Docket Item # 9
BAR CASE # 2015-0269

BAR Meeting
October 21, 2015

ISSUE: New Construction: Building 3
APPLICANT: RTS Associates, LLC
LOCATION: 2 Duke Street
ZONE: W-1 / Waterfront

The application request currently before the BAR is for a Certificate of Appropriateness for the new construction of a multifamily building fronting Wolfe Street (Building 3) at the Robinson Terminal South site at 2 Duke Street.

VIEW FROM S. UNION STREET LOOKING NORTH

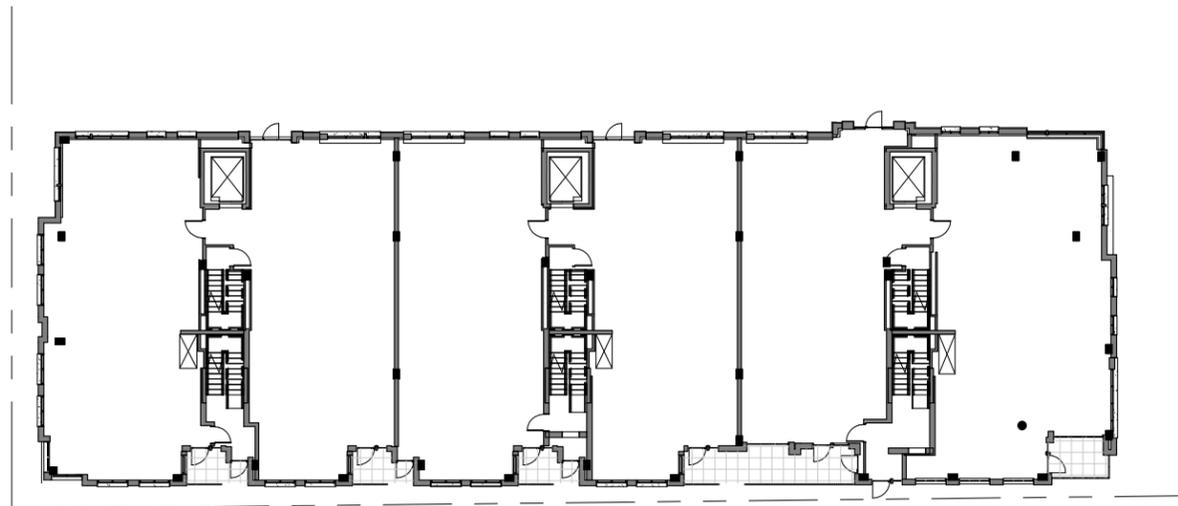
1. The brick at the corner “townhouse” element on the southwest corner of Building 3 should be revised to be either a distinct red brick clearly differentiated from the brick on Building 3A and the Union Street townhouses OR a lighter, buff brick color.

While a City Council member once famously said that “You can’t have too much red brick,” and the applicant has consciously chosen to present a traditional red brick face to Old Town, the exclusive use of red brick on South Union Street and along Wolfe Street could potentially create the visual effect of a red brick wall surrounding the project. One BAR member suggested studying a lighter brick color at the southwest corner of Building 3 to visually interrupt the red perimeter street wall. The corner “townhouse” element could be the buff brick used on the north elevation of Building 3, or it could be red brick that is clearly distinct and distinguished from the red brick used at 3A and the red brick of the South Union Street townhouses. If the choice of a differentiated red brick is pursued, the brick color change should be readily apparent and not subtle.

Staff believes that a lighter colored corner has a lot of urban design merit, particularly as one looks north on South Union Street, but may fragment the overall composition of Building 3 too much. *Staff asks for the BAR to provide guidance as to whether a different color brick is appropriate at the southwest corner of Building 3 and, if so, whether the brick should be a light buff color or a darker red brick, with final details to be worked out by staff through the permitting process.*

OVERALL ELEVATIONS

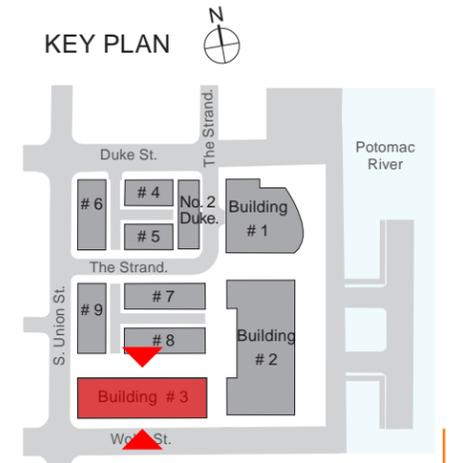
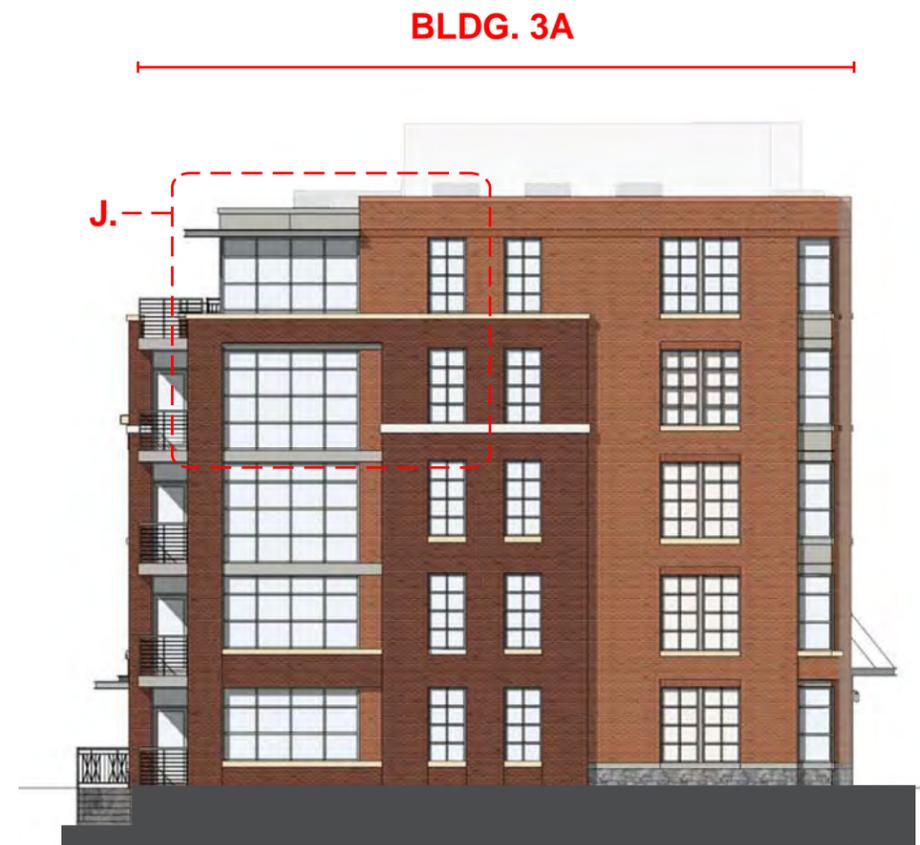
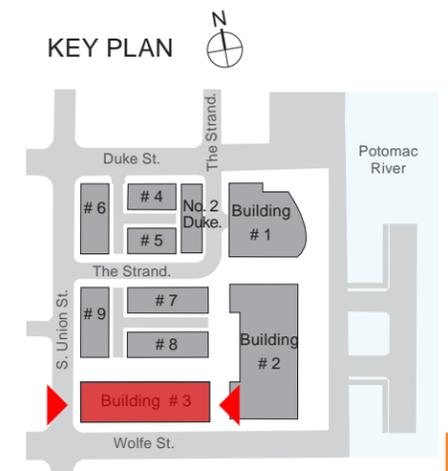
The current submission reflects comments made by the BAR at the last hearing. At the previous hearing, the applicant presented additional options for the treatment of the east end of Building 3, what the BAR has called Building 3A, shown as Option A (more traditional early 20th-century industrial character with a rich red brick) and Option B (more contemporary with a lighter gray color brick) (Figure 1). Both options also featured an emphasized hyphen element connecting Building 3 and 3A on the Wolfe Street elevation. The BAR supported the revised glass hyphen and the design direction of Option A with an additional suggestion that the fifth story of 3A be more transparent/lighter and recall a historic roof monitor or clerestory window. The current submission reflects these revisions (Figure 2). The applicant also introduced a 12 inch setback on the first three floors at the southwest corner of Building 3 to soften and reduce the scale of the bay at this corner. The fifth floor has also been made more transparent with the introduction of wrap-around glass windows in place of the previously proposed punched window openings. Roof variety has been added through the addition of two raised parapets. Additionally, the applicant has removed the rough stone door surround on the north elevation and instead employs

The applicant has strengthened the hyphen by simplifying, recessing, and making it almost entirely glass so that Building 3 and 3A are physically and visually architecturally separate entities.

The applicant has refined the north elevation entrances by removing the rough field stone at the surround and leaving it at the base. The entry surround features dressed stone pilasters that relate to the first floor

a more refined, dressed stone around the entries as well as changed the first floor wall material from gray brick to dressed stone.
